PROJECT
HEIQ Phase 2B

DRAWING
Proposed Elevations Phase 2B Sheet 2

ORIGIN	VOLUME	LEVEL	TYPE	ROLE	NUMBER	REVISION
DAY	XX	XX	DR	A	05-1003	P4

DRAWING STATUS
PLANNING

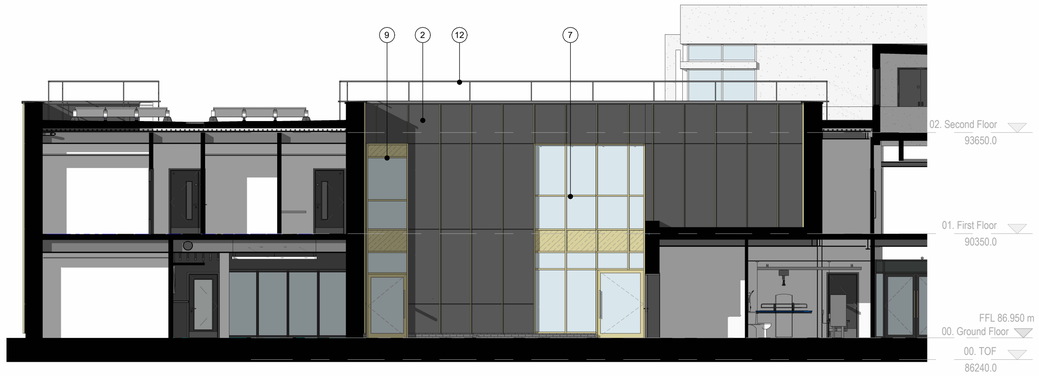
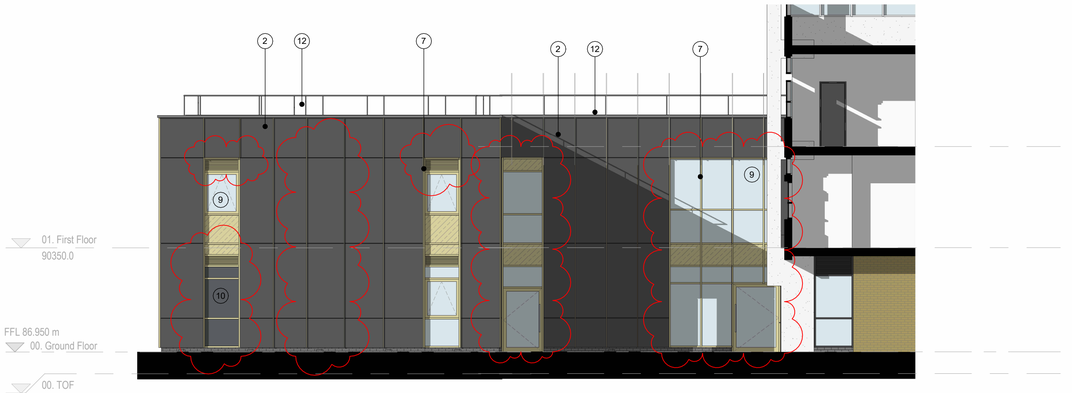
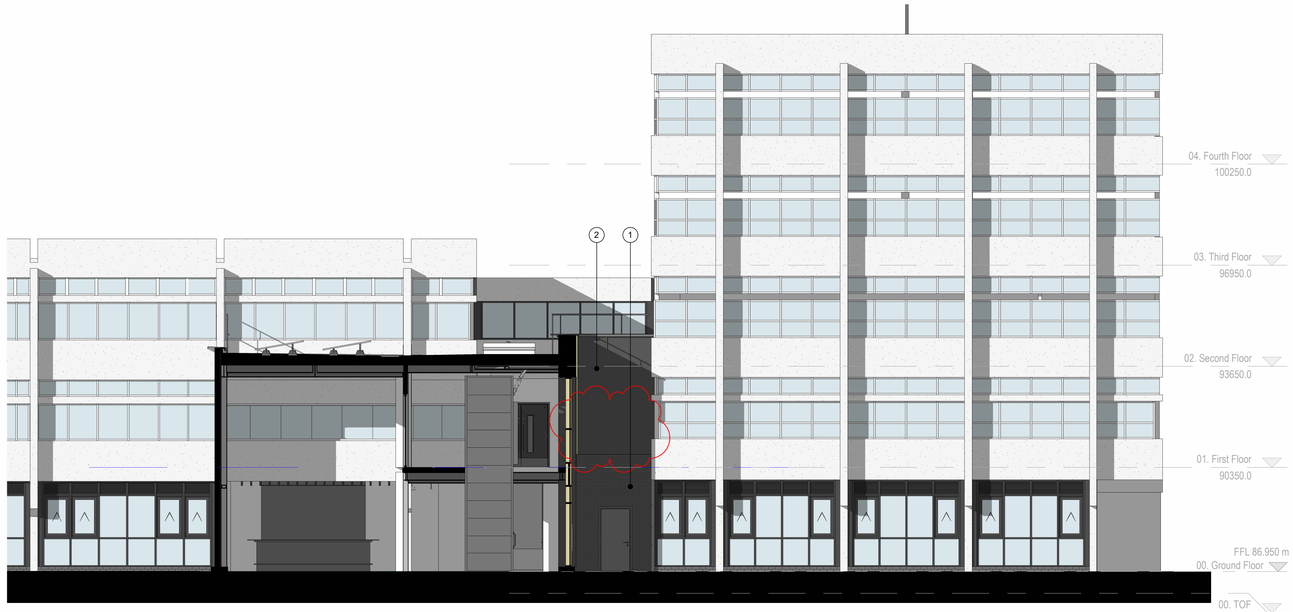
Strucural & Mechanical model to be revised to suit

REV	DESCRIPTION	DATE	REV BY	CHKD BY
P4	Plant room door moved back to original location	24.01.25	OV	
P3	Issued for NMA - as per revision clouds: WEST: louvers added. NORTH: GF window removed and made spandrel panel; middle panels windows removed. NORTH: left hand side panels width amended; curtain walling layout revised following proposed lift; plant room door added. M BLOCK: plant room door removed	09.01.25	GZ	OV
P2	Phase 2B - Revised Planning Issue	04.09.23	RPB	CB
P1	Phase 2B - Planning Issue	10.08.23	RPB	CB
